Field Project Design Review and Quantity Estimation: Watershed Restoration in the
Sultak Watershed, Paktya Province
Henry Shovic, PhD, USDA
hshovic@montana.edu
Oct 13, 2009

For the Tennessee Agri-Business Development Team (TN-ADT)

Sultak Water Restoration Revised Project Design
Tennessee ADT Perspective View
(Using treatments proposed by TN-ADT 10-10-09)

Map 1

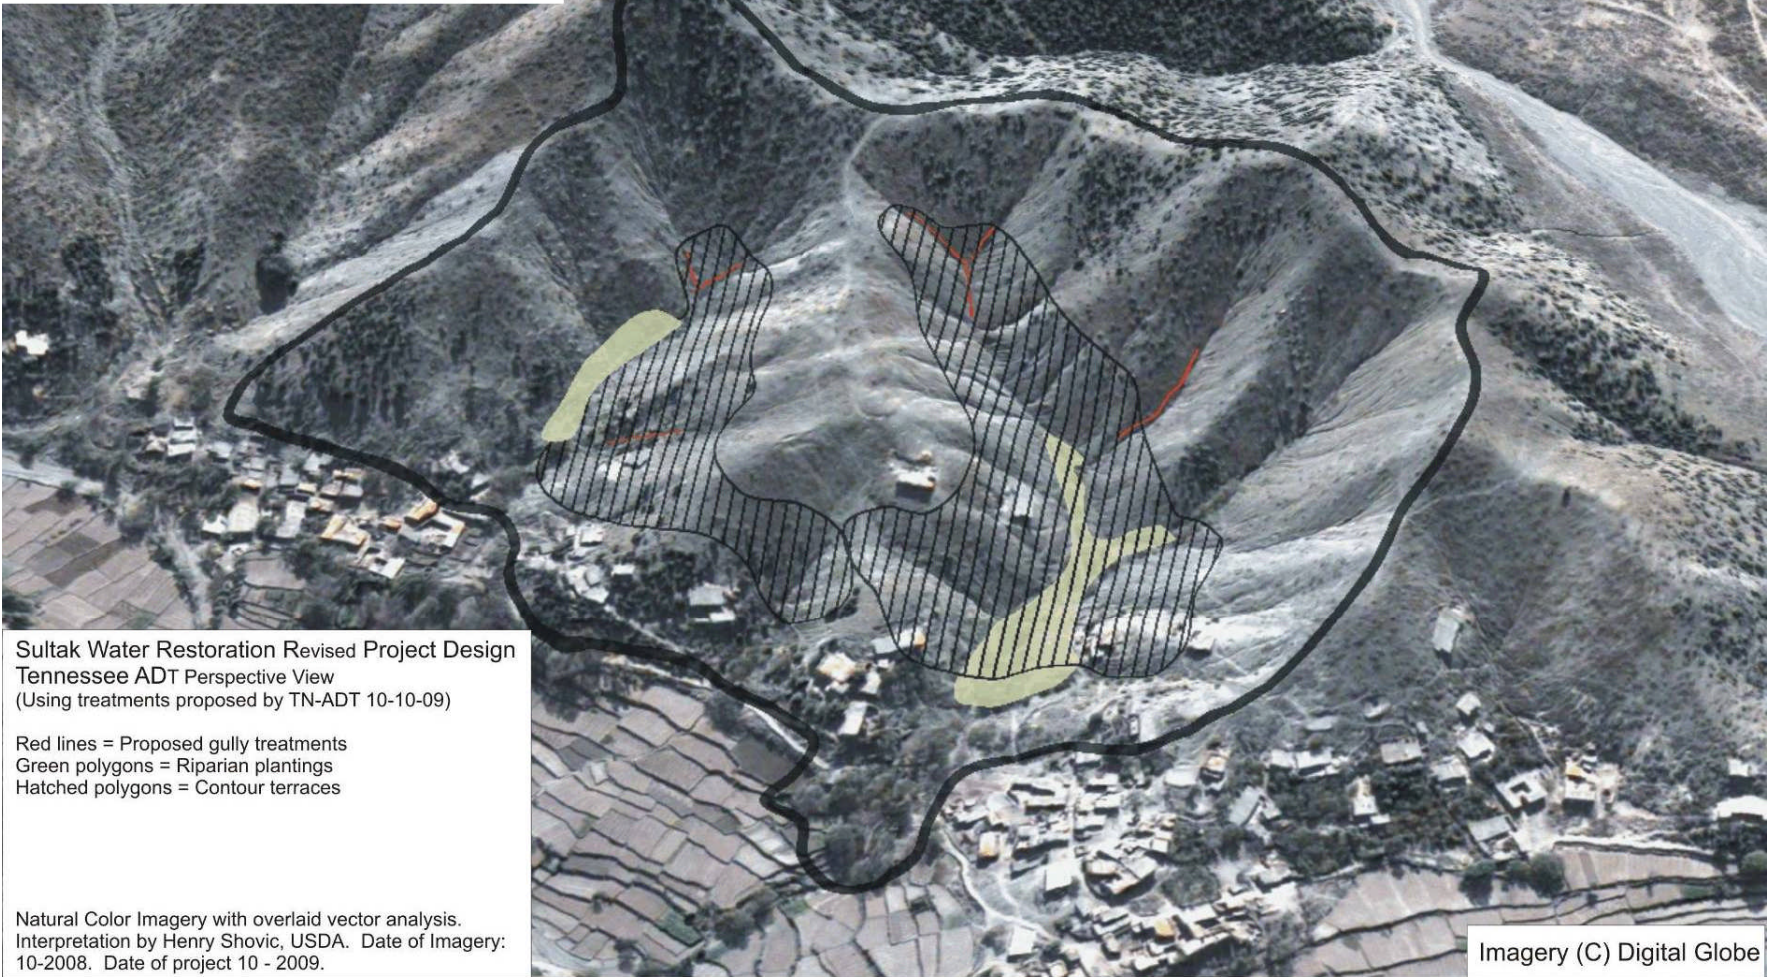
Map 1 shows the overall project area, looking west, showing the project design as submitted by TN-ADT.

Contour Terraces: Where slopes are in an appropriate slope range, install contour terraces to reduce rill erosion and overland flow, and increase infiltration. Approximate area recommended for terraces (within slope range) is 3.3 ha. At 8 m spacing for 25-40% slope, this is **3,976 m of contour terrace by length**. Actual contour locations must be made on the ground. Install contour terraces only on average slopes below 40%.

Check Dams in Gullies: Where slopes are appropriate, install check dams as recommended for 75 m of treatable gullies for a total of **9 rock check dams**. This will reduce gully development and stabilize moderate slopes. This is about 29% of the entire gully system. The remainder is too steep for this kind of restoration.

Bank Protection for Streams: Riparian Plantings are recommended for **7,800 sq. m. or 0.78 Ha**. This will reduce erosion and increase infiltration. Though a large area is shown the map, riparian plantings should be limited to areas where there is evidence of groundwater close to the surface, or should be irrigated for at least two growing seasons.

Map 2

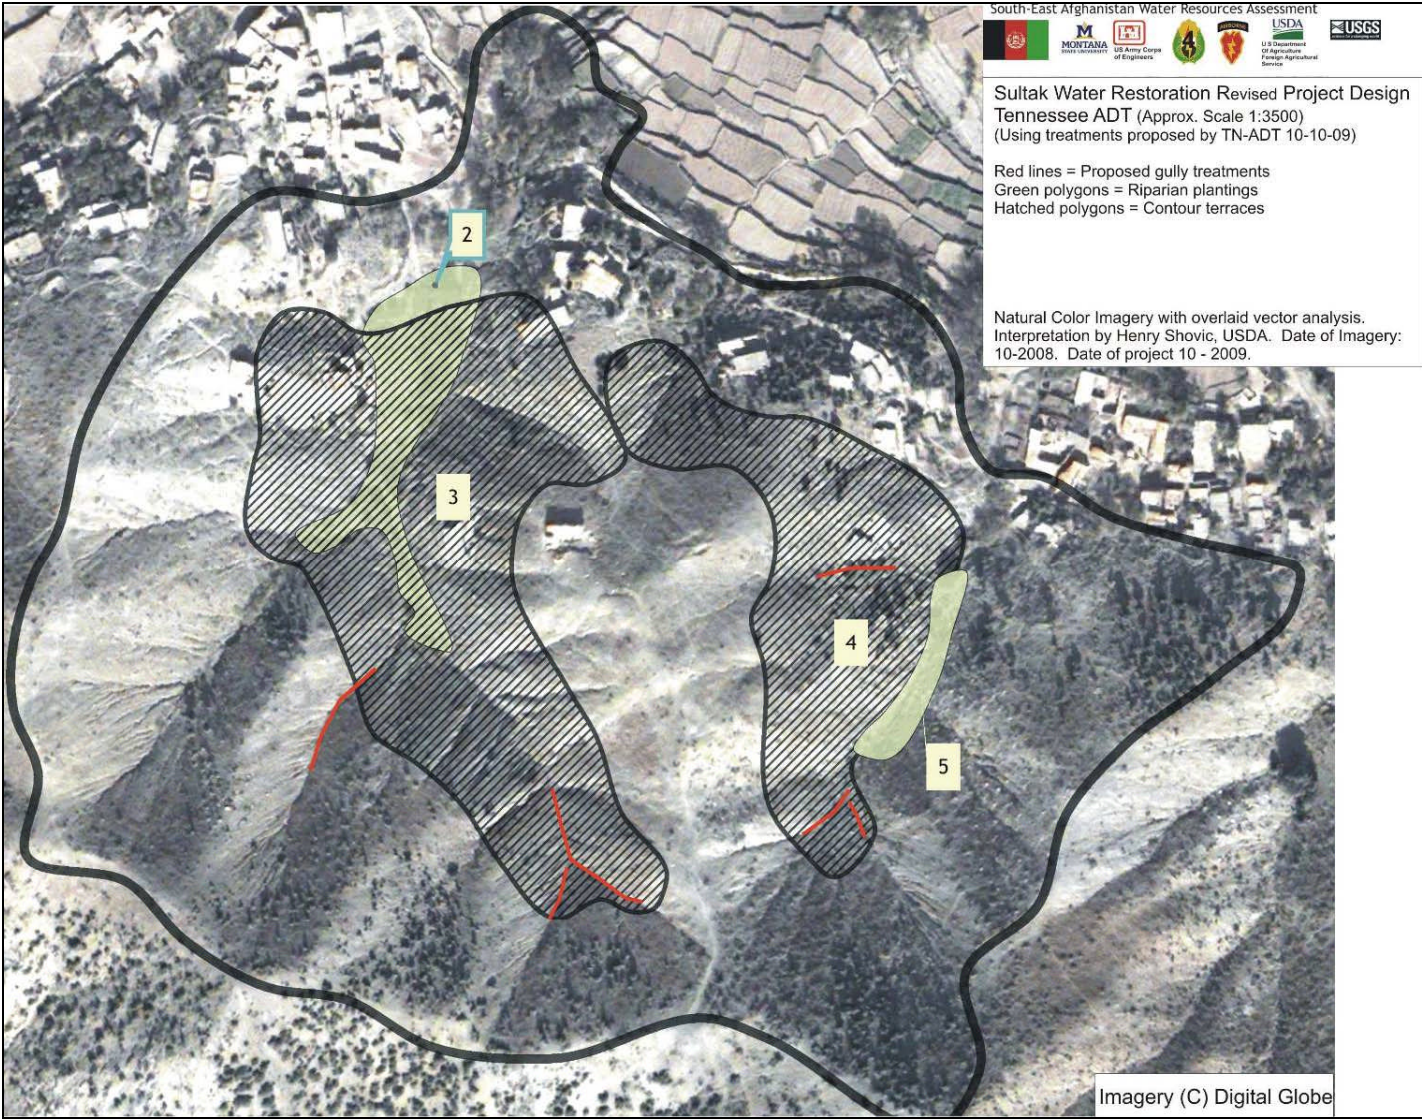
Map 2 shows a plan view of the draft proposal, digitized from project data supplied by TN ADT after field review. This map was submitted by TN-ADT, and is used below to estimate quantities for project submittal.

All terrace polygons have evidence of gully erosion visible on 1:1000 imagery. Polygons for terraces and riparian plantings, and polylines for gully control were digitized from a map provided by TN-ADT (10-9-1009). Areas and length calculations are from GIS, modified by the following:

- 10% area added for planimetric correction for sloping lands on ortho-rectified imagery.
- Proposed treated area for terracing was reduced by 45% to account for slopes over 40% in the proposed treated areas. Terraces are not recommended on slopes over 40%.
- Proposed treated gullies are reduced by 71% to account for steep channel slopes. Check dams are not recommended on channel slopes over 20%.

Polygon 3: 10.5 terraces at 254 m length = 2,667 m of terrace

Polygon 5: 7.4 terraces at 177 m length = 1,309 m of terrace

Total length of gullies proposed for check dam installation: 261 m. Total length of gullies proposed for check dam installation with channel slopes <21%: 75 m. This is 29 percent of the total.

Measured slope average of gully channels (less than 21% slope) is 15%. These gullies appear on imagery to average 2 m wide, and are probably at least that deep. At an average of 15% channel slope and 1 m high, check dam spacing is 9 m. For 75 m of gully within slope constraints, that is $75/9$ or 9 check dams. These should be an average of 2 m wide + 3 m key depth or 5 m total width.
